February 15, 2010
NRC3-10-0012

Subject: Detroit Edison Company Response to NRC Requests for Additional Information
(RAI) Letter No. 16, RAI numbers 02.05.02-1, 02.05.02-3, 02.05.02-4, 02.05.02-8,
02.05.04-27, and 02.05.04-28

**Attachment 1
NRC3-10-0012**

**Response to RAI Letter No. 16
(eRAI Tracking No. 3918)**

Figure 1 – Comparison of 10 Hz hazard results for the Fermi 3 seismic source model using the EPRI 2004 Cluster 2 median model and the Atkinson and Boore (FSAR Reference 2.5.2-265) model.

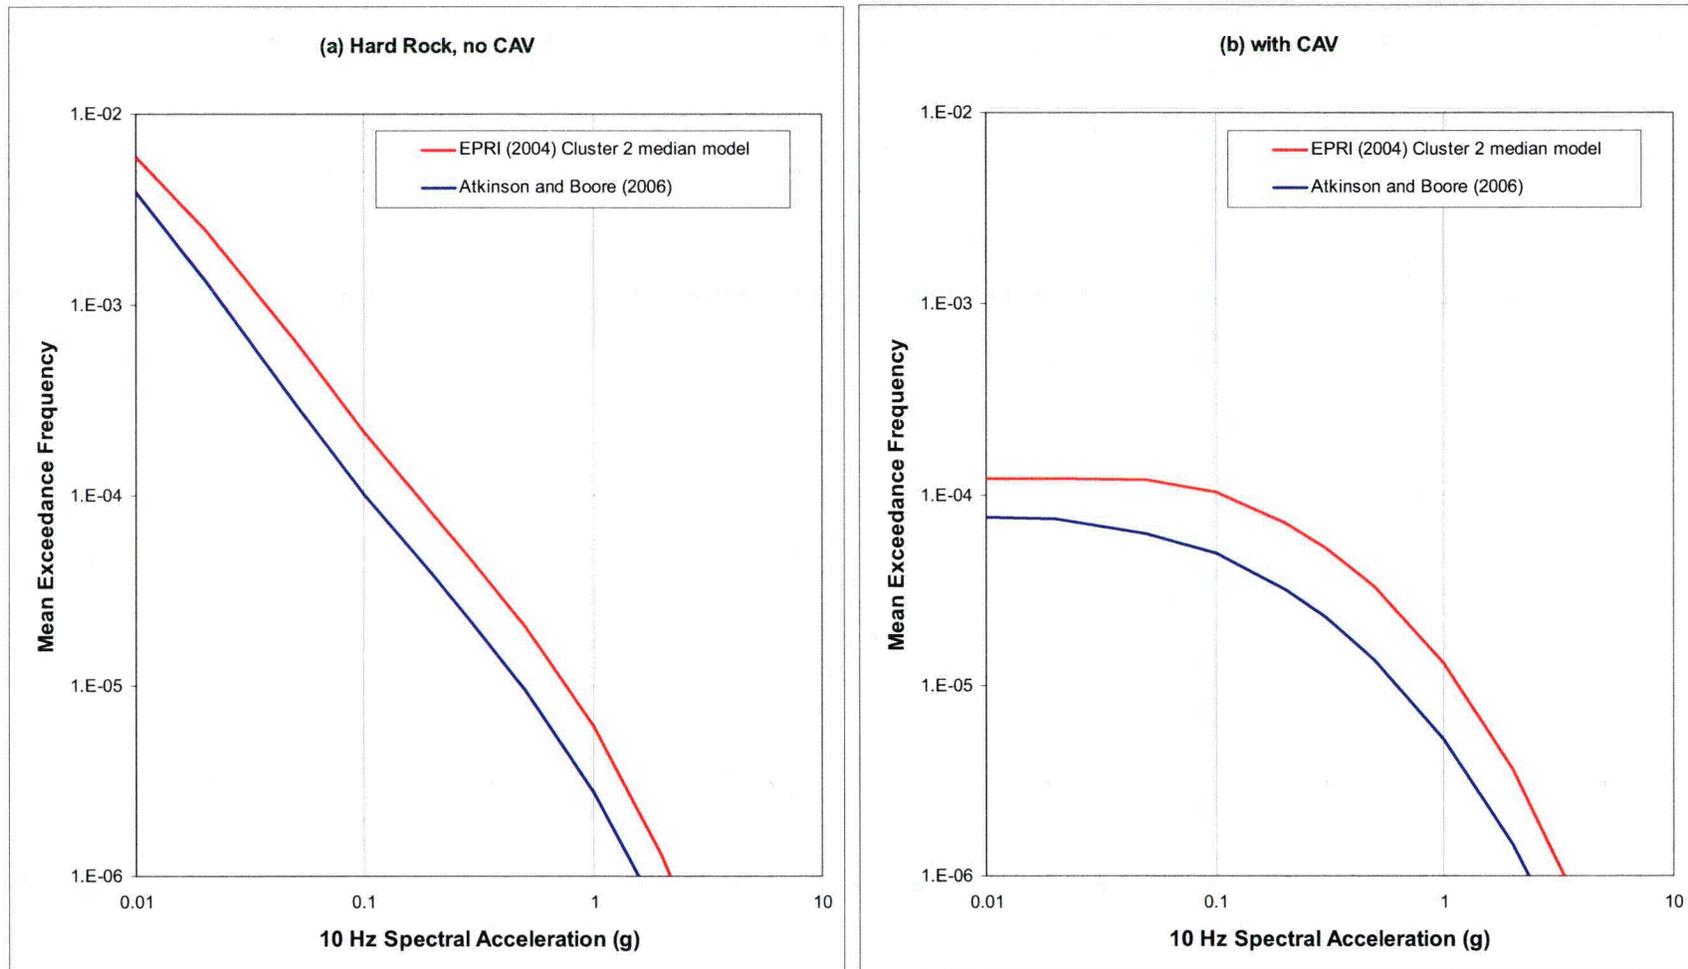
FSAR section 2.5.2.4.2.1 and FSAR Figure 2.5.2–221 compare the EPRI 2004 ground motion models to newer ground motion models for the CEUS. The FSAR concludes that the newer ground motion models fall within the range of the EPRI models. However, it appears that two of the newer models (Atkinson and Boore, 2006, and Tavakoli and Pezeshk, 2005) fall close to (or above) the EPRI models at distances and frequencies relevant to seismic hazard at the Fermi site. For example, the median Atkinson and Boore (2006) model for a M 7.5 event, 1 Hz Spectral Acceleration, and distances of greater than 300 km, is above the EPRI Cluster 2 median and approaches the 95 percent level (FSAR Figure 2.5.2–221). The Tavakoli and Pezeshk (2005) model (M = 5) is also above the EPRI Cluster 3 median at short (less than 20 km) distances and high frequencies. The Tavakoli and Pezeshk model also exceeds the 95 percent level at very short distances. Please explain how the inclusion of these models instead of the EPRI Cluster 2 and 3 models would affect both low and high frequency seismic hazard at the Fermi site.

Figures 1 and 2 compare the results obtained with the EPRI 2004 Cluster 2 median model to those obtained using the Atkinson and Boore (FSAR Reference 2.5.2-265) model for 10 Hz and 1 Hz spectral accelerations, respectively. The Atkinson and Boore (FSAR Reference 2.5.2-265) model produces lower 10 Hz hazard than the EPRI 2004 Cluster 2 model because for most distances the median model is lower (FSAR Figure 2.5.2-221). The Atkinson and Boore (FSAR Reference 2.5.2-265) 10 Hz model only exceeds the EPRI 2004 Cluster 2 model for M 7.5 earthquakes at very small source-to-site distances (FSAR Figure 2.5.2-221). As shown in FSAR Figures 2.5.2-242 through 2.5.2-245, there is little contribution to the high frequency hazard from large magnitude earthquakes at short distances. The Atkinson and Boore (FSAR Reference 2.5.2-265) 1 Hz model produces higher hard rock hazard than the EPRI 2004 Cluster 2 model because the low frequency hazard is dominated by large, distant earthquakes and the Atkinson and Boore (FSAR Reference 2.5.2-265) model is somewhat higher for these conditions. However, when the CAV model is applied, the Atkinson and Boore (FSAR Reference 2.5.2-265) model produces similar hazard to the EPRI 2004 Cluster 2 model because the Atkinson and Boore (FSAR Reference 2.5.2-265) model predicts lower peak ground accelerations, and thus lower probabilities that earthquakes will produce a CAV value in excess of 0.16 g-sec.

Figure 1 – Geometry of the Bechtel sources that cover the Anna, Ohio, and Northeastern Ohio areas.

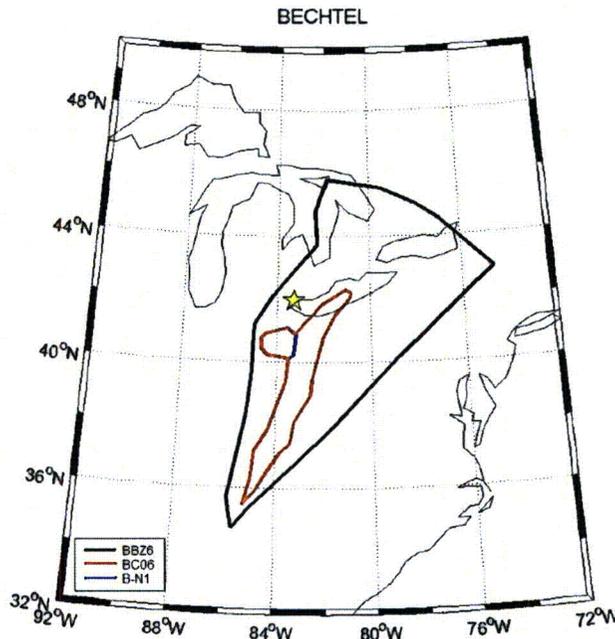
In order for the staff to verify the adequacy of the Fermi 3 site PSHA relative to the seismicity in the Anna, Ohio and Northeast Ohio areas, please provide the input source parameters (e.g. activity rates) as well as the specific source geometries used by each of the EPRI Teams to model these two potential sources. In addition, provide the corresponding PSHA hazard curves for these two sources.

The Electric Power Research Institute (EPRI) (Reference 2.5.2-202) seismic sources for the Bechtel team covering the Anna, Ohio, and Northeastern Ohio areas are: background source BBZ6; source B-N1 (Anna, Ohio area); and the combined source BC06 (Sources BEC-27 and BEC-N1 on FSAR Figure 2.5.2-204). Background source BBZ6 also covers the areas of B-N1 and BC06. The background source is always active ($P^* = 1$), source B-N1 has P^* of 0.6. The combined source BC06 receives a weight of 0.12 (Table 1). The Bechtel team (Reference 2.5.2-201, volume 10) assigned probabilities of activity of 0.6 and 0.2 to sources BEC-N1 and BEC-27, respectively and also stated that these were independent probabilities. These interpretations produce four alternatives: BEC-N1 alone active with probability 0.48, BEC-27 alone active with probability 0.08, both active (the combined source BC06) with probability 0.12, and neither active with probability 0.32. In defining the source set for the Fermi site calculation, EPRI (Reference 2.5.2-202) found that the option of BEC-27 alone active contributed less than one percent to the total hazard and this option was not included in the Bechtel team source set used at that time. The probability mass of 0.08 was assigned to neither source active case in order to maintain the correct probability that BEC-N1 is active (0.48 plus 0.12 sums to 0.6). Testing done in developing the source set for the Fermi 3 probabilistic seismic hazard analysis (PSHA) also produced the same result and the source combinations for BEC-N1 and BEC-27 used by EPRI (Reference 2.5.2-202) and listed in Table 1 below were used for the Fermi 3 PSHA

reported in FSAR Section 2.5.2.4. Figure 1 shows the geometry of the three zones and the location of the Fermi 3 site (yellow star) for reference.

Figure 1 – Estimated Shear Wave Velocity Profiles Used for the Backfill Surrounding the Embedded Walls at R/FB Location for the Sensitivity Analyses.

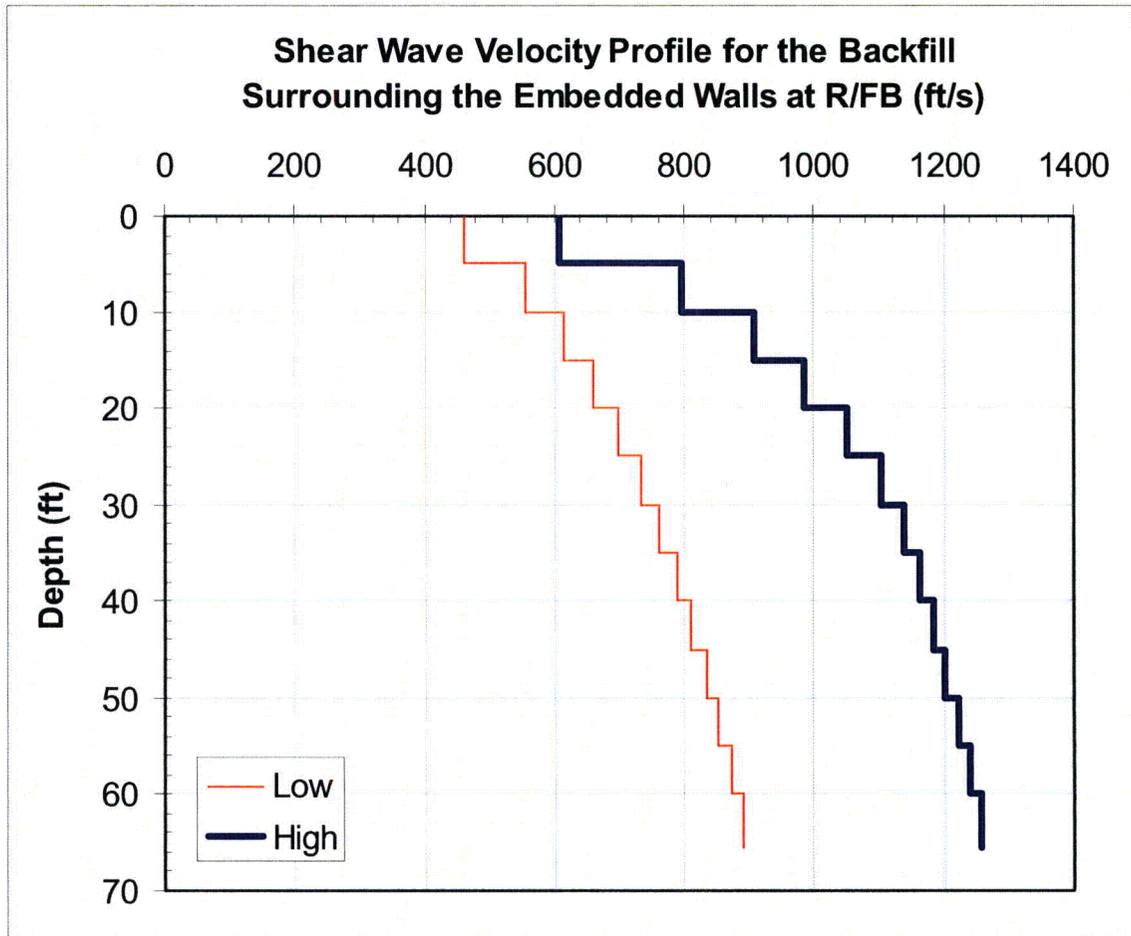
- a) Please provide enough details on each step of the Ostadan method as applied to arrive at the seismic lateral earth pressures presented on FSAR figures 2.5.4-230 and 2.5.4-231. If the Ostadan method was simplified or modified in developing the seismic lateral earth pressures, please provide reasons for the changes.*
- b) Please provide an explanation on why the dynamic lateral earth pressures presented in FSAR figures 2.5.4-230 and 2.5.4-231 are appropriate for the R/FB and CB walls given the heterogeneous materials (granular fills, lean concrete, rock) surrounding those walls.*

- The full soil column consists of the truncated soil column plus the soil column above the foundation base representing the engineered granular backfill. The full soil profiles for the R/FB consists of the truncated soil column shown in FSAR Tables 2.5.2-220 (sheet 2 of 4) plus the soil column above the foundation base as shown on attached Figure 1. The full soil profiles for the CB consists of the truncated soil column shown in FSAR Tables 2.5.2-220 (sheet 3 of 4) plus the soil column above the foundation base as shown on attached Figure 2.

- Two shear wave velocity profiles (high and low) as shown on Figures 1 and 2 are estimated for the soil column above the foundation base for the sensitivity analyses. The high and low shear wave velocities are used to investigate the effects of shear wave velocity of the backfill on the ground response motion.
